# Access Compliance Report

## Public Rights-of-Way

Intersection ID: 30505	Main Street: HARVEST_TIME_CT	Cross Street: PLANTERS_ESTATES_DR	Location: SW
ADA ID: 7D9A573085D2	Ramp Type: PerpDiag	Initial Pass/Fail: Fail	Overall Compliance: No
Severity Score: 21.25			
Codes/Mitigation Info/Possible Solution		Field Measurements/Component Compliance

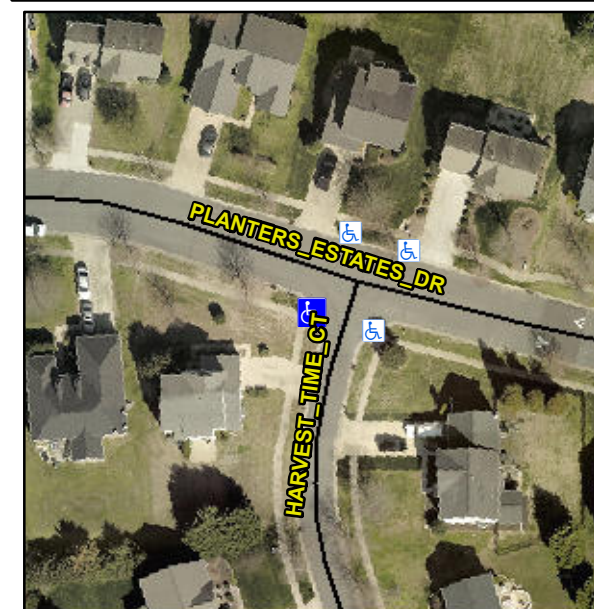
**R304.5.1, R304.2.2**

Compliance	Description	Data	Compliance	Description	Data
N/A	Ramp Length (in)	42.0	No	Ramp Slope (%)	11.0
No	Ramp Width (in)	43.5	Yes	Ramp XSlope (%)	0.4
N/A	Flare Type LT	N/A	N/A	Flare Type RT	N/A
N/A	Flare Slope LT (%)	N/A	N/A	Flare Slope RT (%)	N/A
N/A	Flare Traversable LT?	N/A	N/A	Flare Traversable RT?	N/A
N/A	Landing Length (in)	N/A	N/A	DWS Provided?	N/A
N/A	Landing Width (in)	N/A	N/A	DWS Contrast?	N/A
N/A	Landing Slope (%)	N/A	N/A	DWS Length (in)	N/A
N/A	Landing X Slope (%)	N/A	N/A	DWS Full Width?	N/A
N/A	Landing Curb? (Y/N)	N/A	N/A	DWS Offset (in)	N/A
N/A	Shared Landing?	N/A			
N/A	Gutter Ponding?	N/A	N/A	Gutter Slope (%)	N/A
N/A	Gutter Lip Ht (in)	N/A	N/A	Gutter X Slope (%)	N/A
N/A	Painted X Walk1?	No	N/A	Painted X Walk2?	No
	X Walk 1 Direction	To SE		X Walk 2 Direction	To NE
N/A	X Walk 1 Width (in)	N/A	N/A	X Walk 2 Width (in)	N/A
	X Walk 1 Slope (%)	1.8		X Walk 2 Slope (%)	2.9
	X Walk 1 X Slope (%)	2.1		X Walk 2 X Slope (%)	1.0

**Remove & Replace Curb Ramp With Two New Directional Ramps or Equivalent.**
